PASADENA WATER AND POWER

SUBJECT: National Aeronautics and Space Administration (NASA), Jet Propulsion Laboratory (JPL) Technical Memorandum (TM): Additional Investigation Results, January 31, 2007

Review and Comments of NASA's Jet Propulsion Laboratory 31-Jan-07 Technical Memorandum: Additional Investigation Results

REVIEW AND COMMENTS OF NASA'S 31-JAN-07 JET PROPULSION LABORATORY TECHNICAL MEMORANDUM: ADDITIONAL INVESTIGATION RESULTS

Figure 30

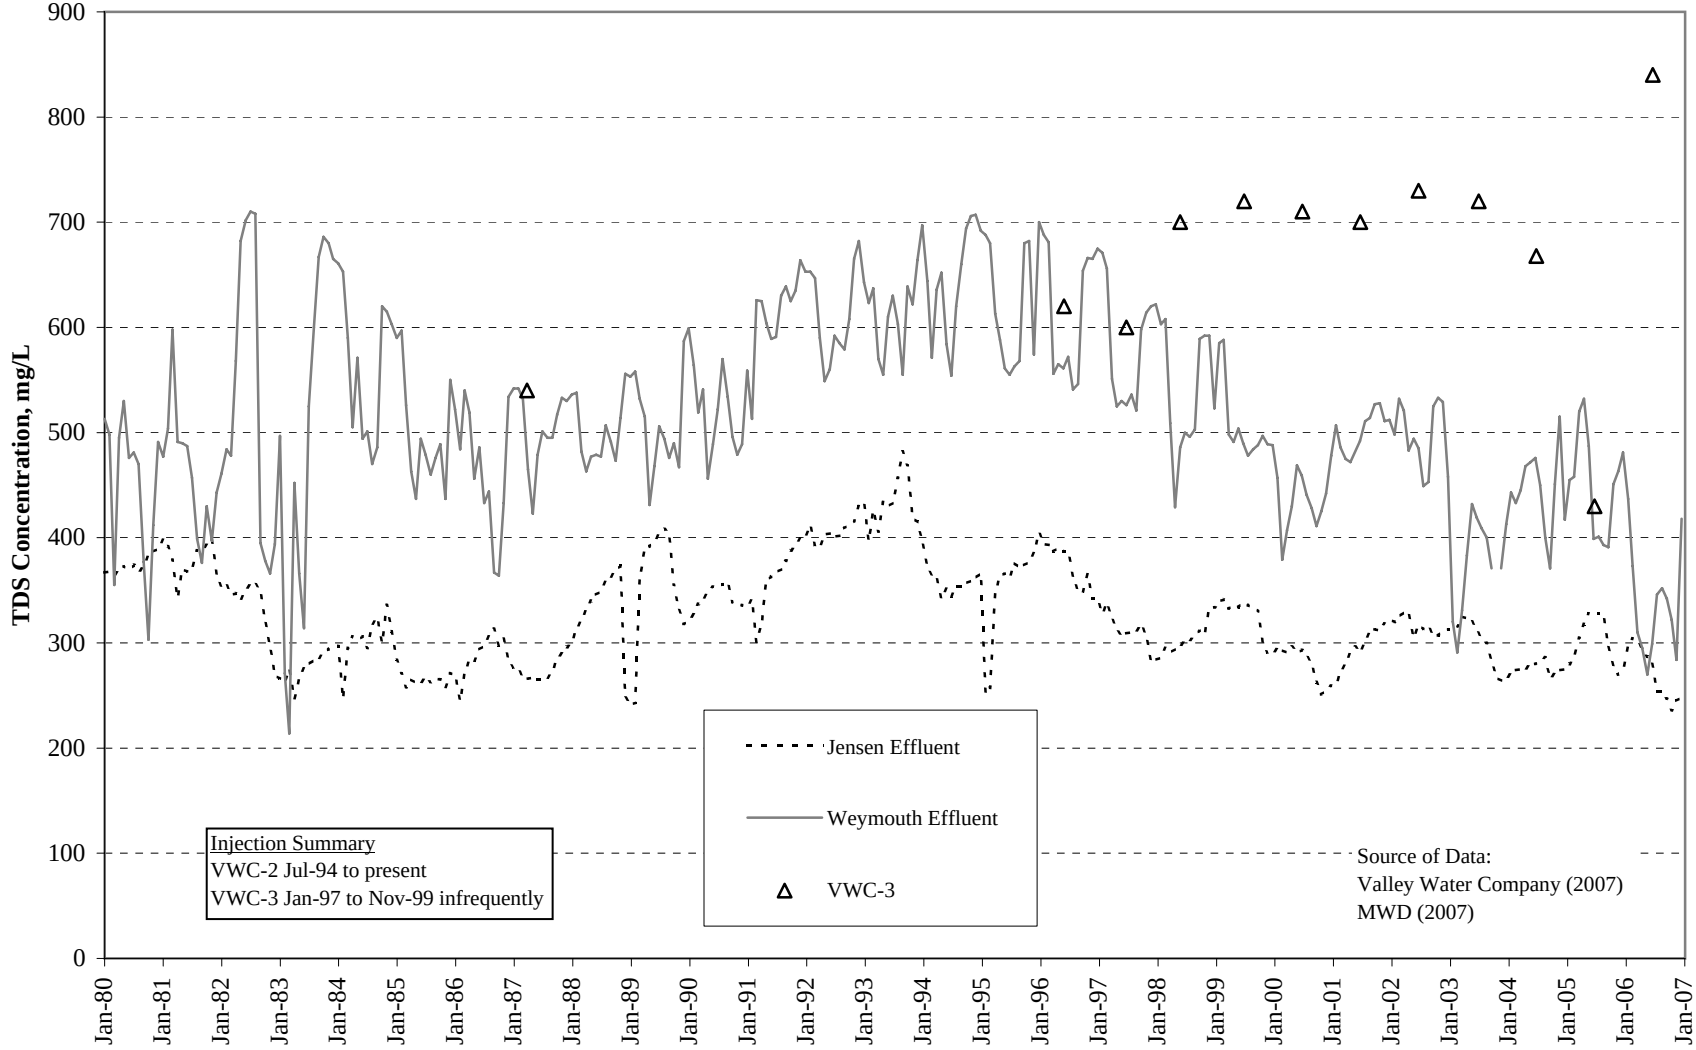
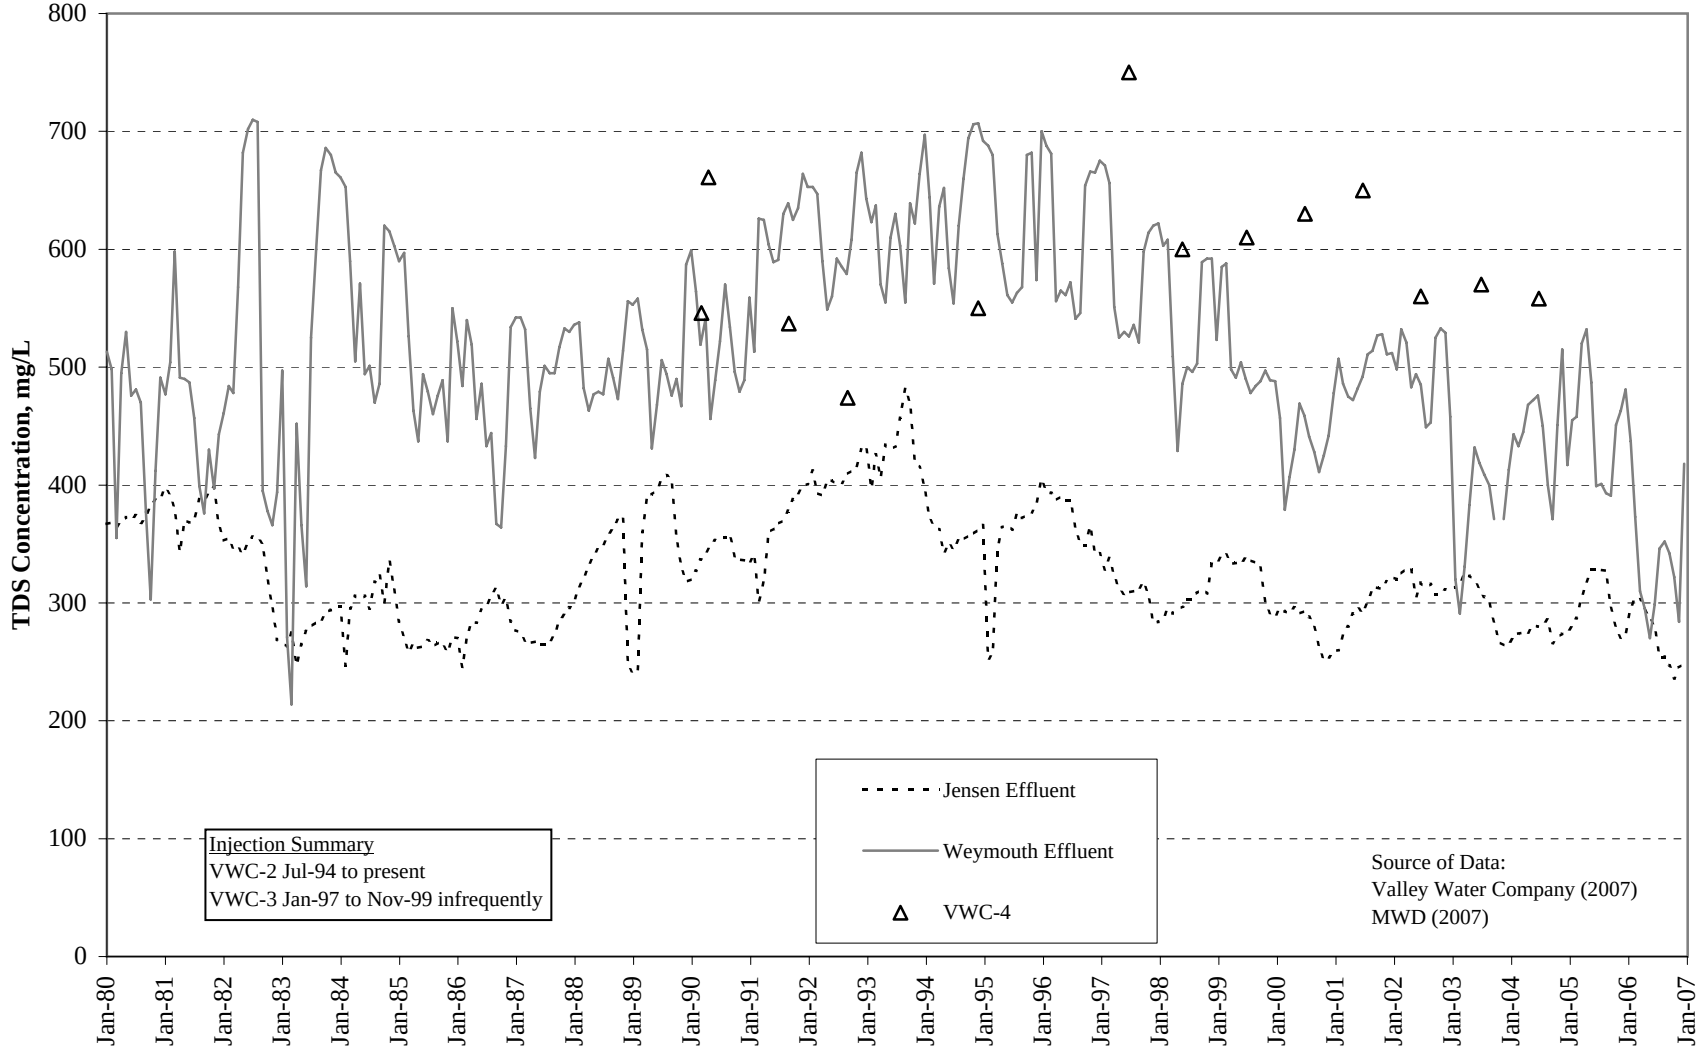
It is agreed that sulfate in the Basin has increased in some areas, possibly due to the importation of Colorado River Water and recharged as return flow including septic tank discharge in unsewered areas. Also, in the Sunset Reservoir and Valley Water Company wells, historical sulfate trends show a range of increases, no changes and decreases as shown in Figures 5 – 31, and summarized in Table 1.

If the mechanism described by NASA for concentrating perchlorate in the ground water to levels above the source/recharge water was valid, it would be expected that other salts, such as sulfate, chloride and TDS would also increase in the ground water to concentrations exceeding the recharge water. Figures 5 through 13 show that sulfate in ground water (both Sunset Reservoir area and Valley Water Company wells) have mostly remained at or below imported Colorado River and State Project water concentrations, while Figures 32 through 36 show perchlorate in ground water significantly higher than concentrations in imported water for wells hydraulically downgradient of the JPL facility.

Monthly Average Perchlorate Concentrations in Imported Water and Sunset Well (P-SUN)

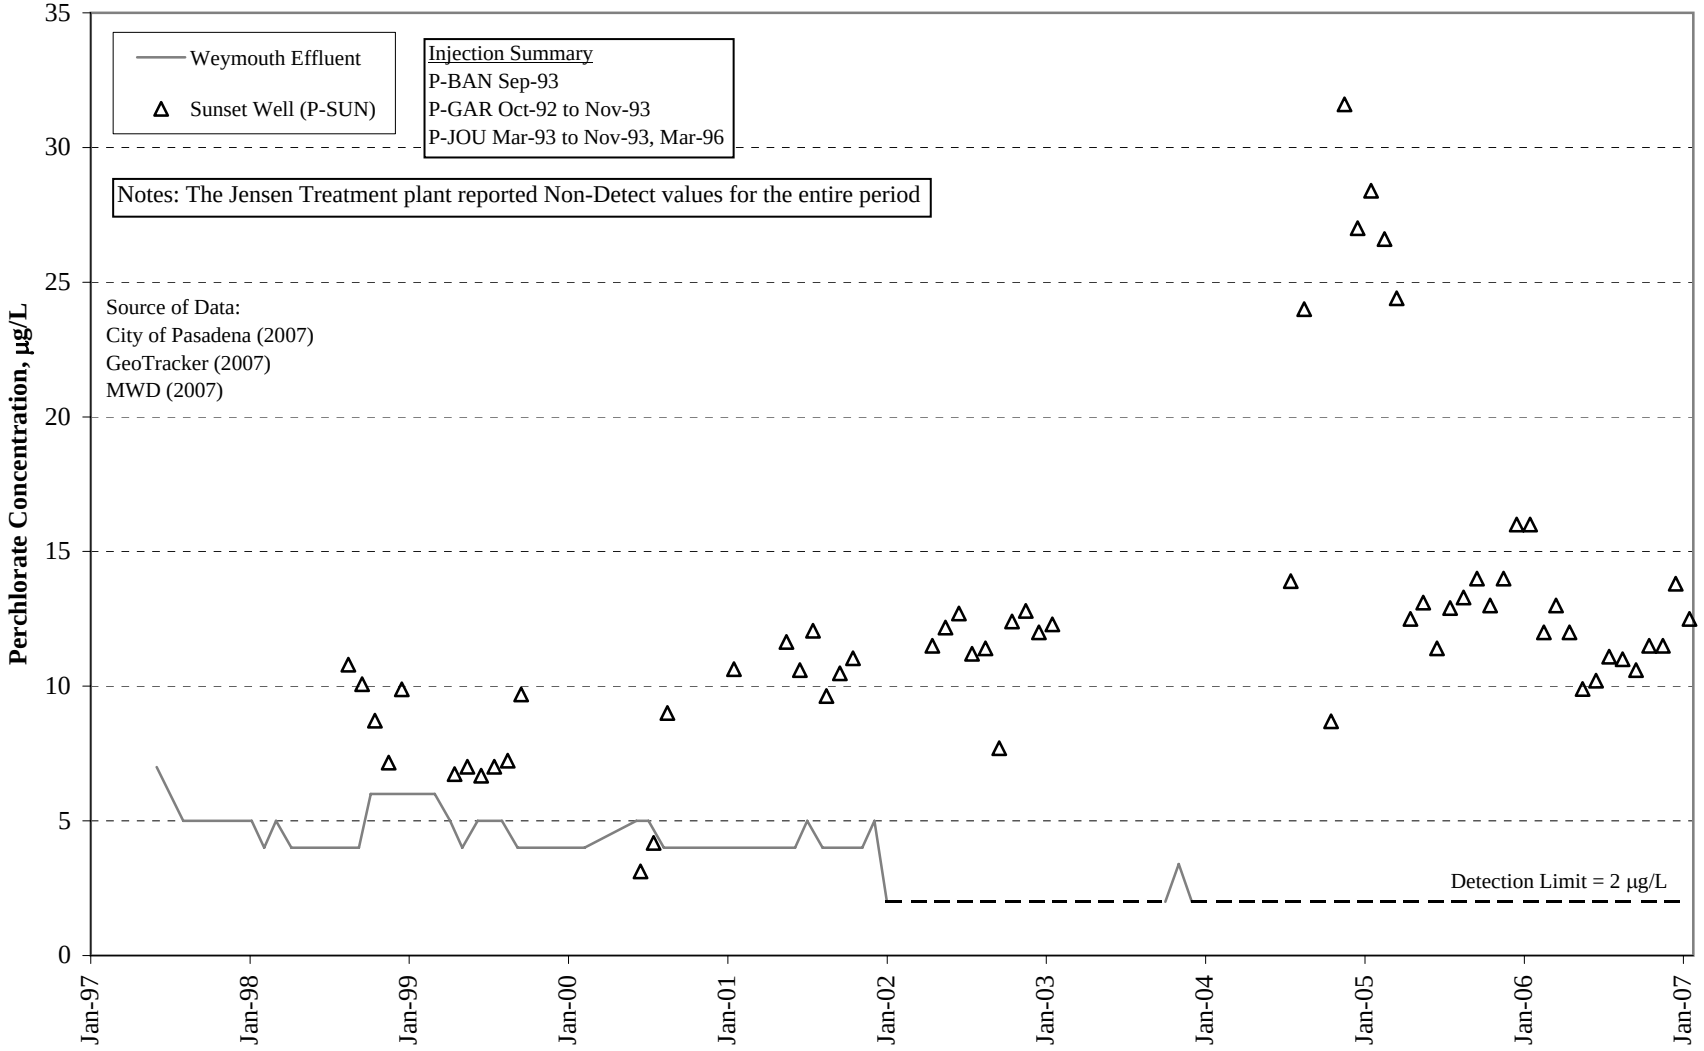
Weymouth Plant	Blend of State Project water and Colorado River water (detectable perchlorate concentrations in the plant effluent from 1997 to 2007 ranges from 3.4 μg/L to 7 μg/L, and averages 4.6 μg/L. Non-detects (i.e., less than 2 μg/L) have been reported since December 2003, see Figure 32)
